UNITED STATES PATENT AND TRADEMARK OFFICE

Office Action Summary	Application No. 10/534,451	Applicant(s) HERDA, EDUARD	
	Examiner TIMOTHY KENNEDY	Art Unit 1791

DETAILED ACTION

Figure A)

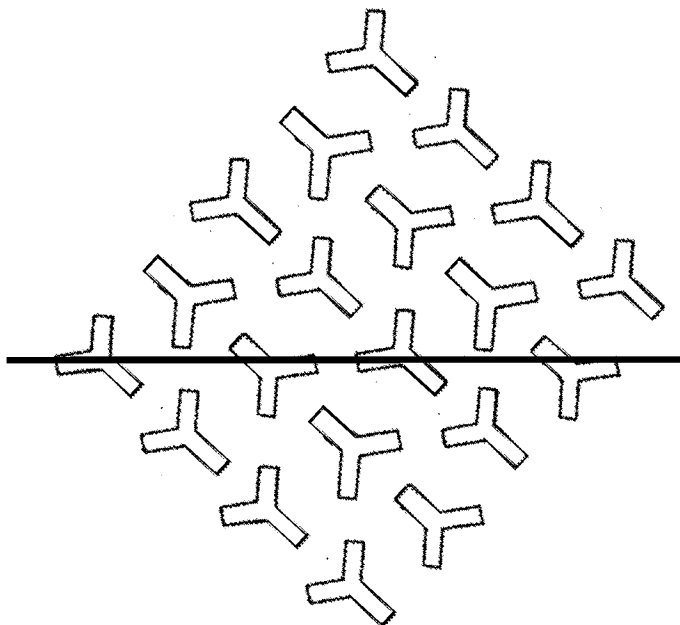
13. When Figure 4B is expanded to show more rows, and then rotated, a new set of rows appear that anticipate the claimed structure of the spinneret plate and holes as claimed in claim 1.

14. As seen in Figure A the trilobal holes are offset to each other from row to row, and the holes also are position differently through a rotation (the line is to show the position of the rows)
